香港觀鳥會
THE
HONG
KONG
BIRD
WATCHING
SOCIETY
Since 1957 成立

**Comments on the Stage 2 Public Engagement Digest for Underground Space
Development in Selected Strategic Urban Areas**

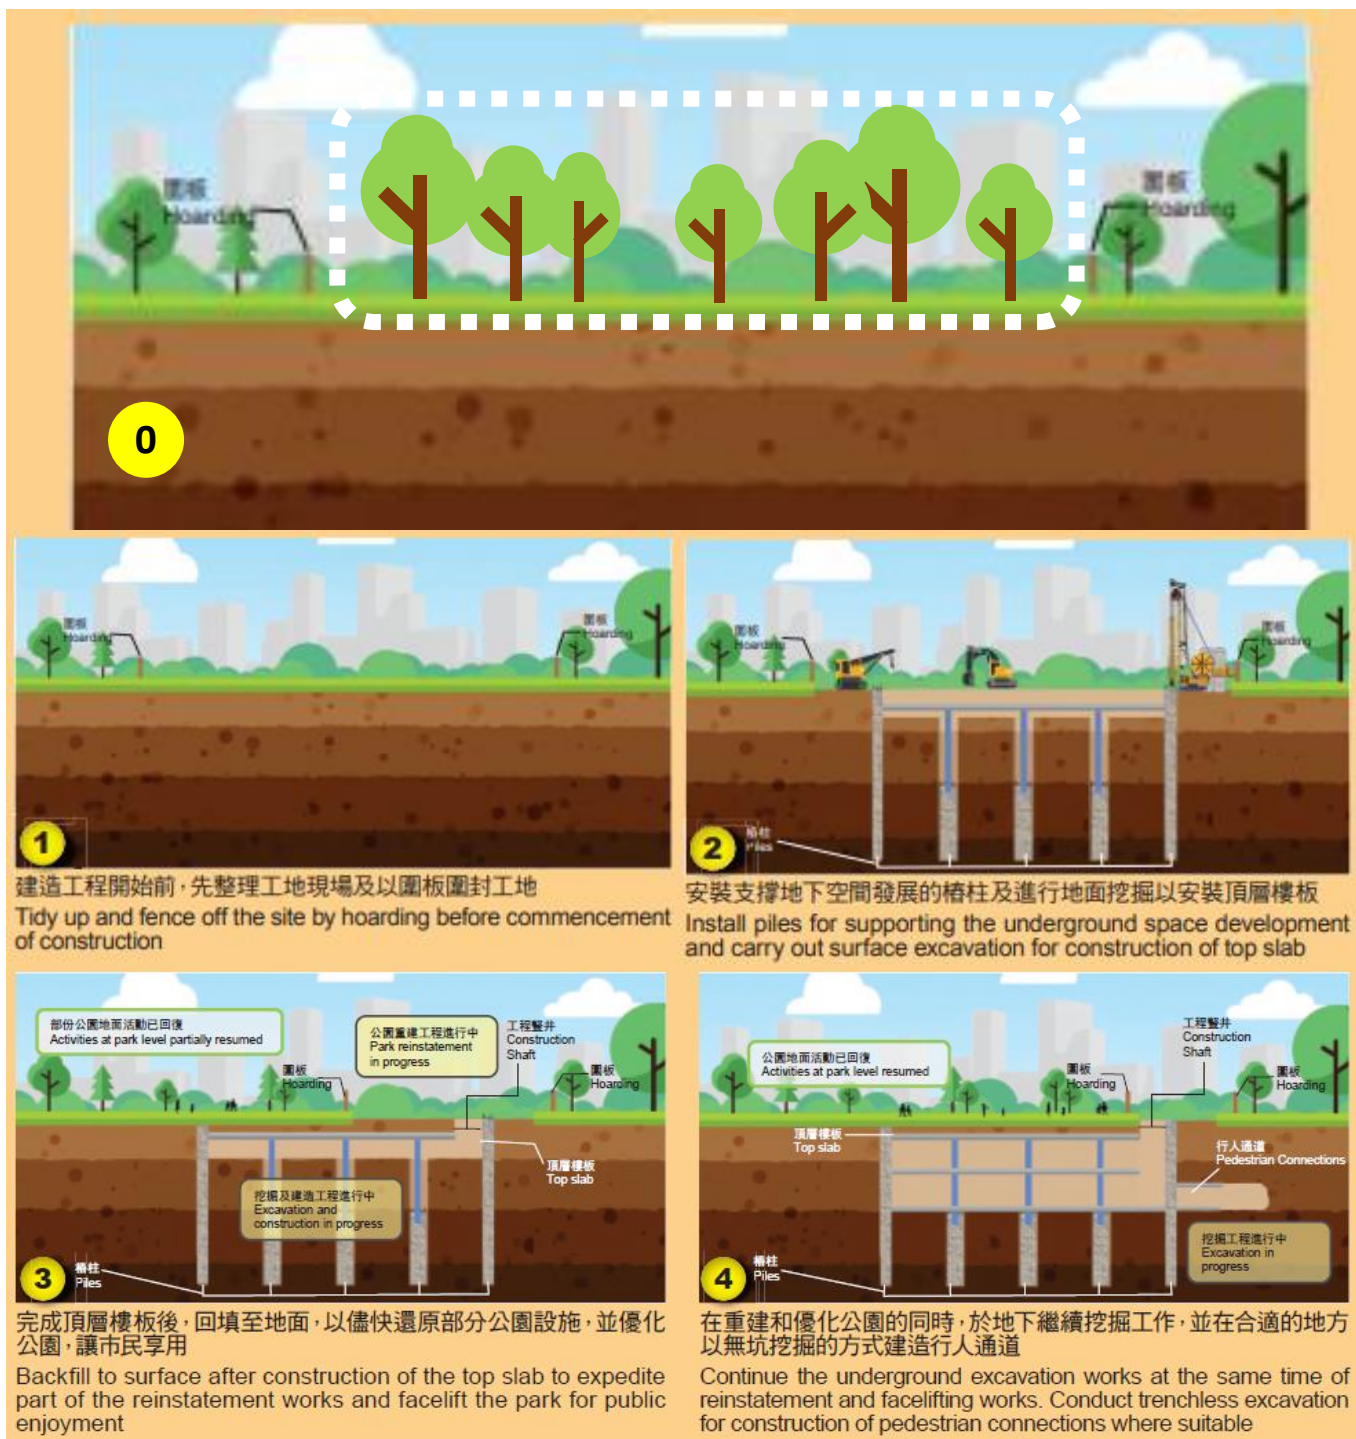
2.3 However, from the paper of Pilot Study on Underground Space Development in Selected Strategic Urban Areas – Stage 2 Public Engagement Digest (the paper), surface excavation would be carried out for the construction of underground space (Figure 1). From Google Earth aerial photograph, most of the excavation site, which is about approximately 33,250 square metre and accounting for 25% of Kowloon Park area, is currently covered with tall trees (Figure 2). It is also mentioned in the Focus Group Meeting held on 5 June 2019 that there would be 300 trees affected under the proposed surface excavation works. We are concerned the underground works required may directly or indirectly damage the tree root systems and adversely affect the health and survival of these trees, which may in turn disturb the roosting and foraging grounds for birds.

3.2 However, as mentioned in the previous section, the extensive surface excavation associated from the proposed “*Top-down*” construction method which will be associated with an extensive vegetation clearance and removal of trees, will cause serious disruption to the ecology of the park. Even if there is transplantation of some of the affected trees, the health of the tree is greatly compromised during the process and there is no guarantee that all tree individuals will healthily survive after the transplantation. We consider *in-situ* conservation should be regarded as the first priority whereas transplantation should be regarded as last resort for mitigation measure.

- 3.3 Moreover, the four diagrams at page 23 of the paper showing the construction procedures of the proposed “*top-down*” approach only illustrate the process of turning a “grassland” to a land covered with trees, giving the public a false impression that the proposed project will plant more trees in Kowloon Park and enhance its aesthetic value. This is misleading as the current status of the well-wooded Kowloon Park was not shown, while the works required to reach the “grassland” appearance in the first diagram (i.e. tree removal/transplantation, site clearance and erection of hoardings) were hidden. (Figure 1)
